PUBLIC INTEREST REVIEW FOR GROUNDWATER APPLICATIONS

TO:		Water	Rights S	ection					Date	·	Janua	ry 29, 2	016	
FROM		Groun	dwater So	ection			ra C Bou		er					
SUBJE	CT:	Applio	cation G-	18186			ewer's Nam persedes		ew of <u>na</u>			Date of Re	view(s)	
OAR 69 welfare, to determ	90-310-1 safety and mine when	30 (1) The state of the state o	he Departi h as descri presumpti	MPTION; ment shall pa bed in ORS on is establi ew is based	resume that 537.525. D shed. OAR	a propose epartment 690-310-	ed ground staff revi 140 allow	iew g	groundwater e proposed u	r applica use be m	tions u odified	nder OAI l or condi	R 690-31 tioned to	0-140 meet

A. <u>GEN</u>	NERAL	INFO	RMATI(<u>)N</u> : A _l	oplicant's N	lame:	David S	athe	er		(County: _	Clacka	mas
A1.	Applica	nt(s) see	ek(s) 0.6	8 cfs from	n <u>2</u>	well(s) in the	1	Willamett	e				_Basin,
		Molalla-	Pudding			subba	asin (Yod	ler qu	uad)					
A2.	Propose	d use <u>N</u>	ursery U	se (irr & a	g) 27.3 ac	<u>re</u> Seas	onality:	yea	r round					
A3.	Well an	d aquife	r data (att	ach and nui	mber logs f	or existin	g wells; ı	nark	k proposed	wells as	such ı	ınder log	gid):	
Well	Logic	l	Applicant' Well #	S Propose	ed Aquifer*	Propo Rate			Location

Water-Level Trends in Nearby Wells

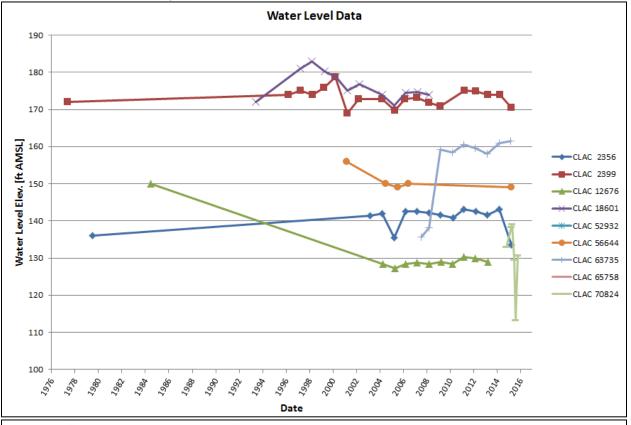
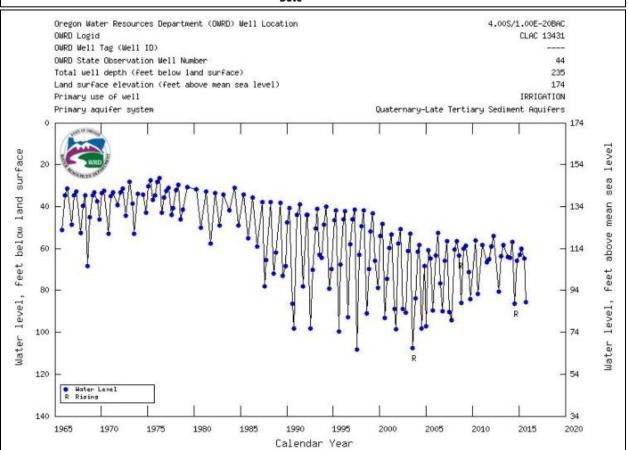
hydrograph below). However, except for CLAC 70824, the water levels in nearby wells are measured in the spring as part of permit conditions. Water level measurements from State Observation Well 44 (CLAC 13431, located ~4 miles to the north) indicate that the seasonal fluctuation in the alluvial aquifer may be increasing, at least in that portion of the valley (see hydrograph below). In the spring of 2015, OWRD started collecting quarterly water level measurements at CLAC 70824. Over time there will be sufficient measurements to determine the seasonal pattern in the vicinity of CLAC 70824. Increased	<u>I</u> <u>1</u> <u>2</u> <u>c</u>	n th 1998 grain hrou confi	is location, low permeability Willamette Silts is found from land surface to a depth of 20-40 feet (Gannett and Caldwell,). The water table occurs near land surface within the Willamette Silt. A thick (>1000 feet) sequence of mostly fine ed alluvium with thin beds of sand and gravel occurs beneath the Willamette Silt. Productive sand and gravel beds occur ighout the sequence separated by layers of lower permeability silts and clays (Conlon et al., 2005) which progressively ne deeper water-bearing zones (Woodward et al., 1998). Because the productive sand and gravel beds are confined, the of depression from the wells will spread over a broad area and interact with multiple streams. The interbedded, fine-

permit conditions. Water level measurements from State Observation Well 44 (CLAC 13431, located ~4 miles to the north) indicate that the seasonal fluctuation in the alluvial aquifer may be increasing, at least in that portion of the valley (see hydrograph below). In the spring of 2015, OWRD started collecting quarterly water level measurements at CLAC 70824. Over time there will be sufficient measurements to determine the seasonal pattern in the vicinity of CLAC 70824. Increased			
Over time there will be sufficient measurements to determine the seasonal pattern in the vicinity of CLAC 70824. Increased	i	oerm ndic	it conditions. Water level measurements from State Observation Well 44 (CLAC 13431, located ~4 miles to the north) ate that the seasonal fluctuation in the alluvial aquifer may be increasing, at least in that portion of the valley (see
groundwater development in the area indicates a need for additional water-level monitoring (7N) if this permit is issued.	(Över	time there will be sufficient measurements to determine the seasonal pattern in the vicinity of CLAC 70824. Increased

٤	grou	ndwater development in the area indicates a need for additional water-level monitoring (7N) if this permit is issued.
	_
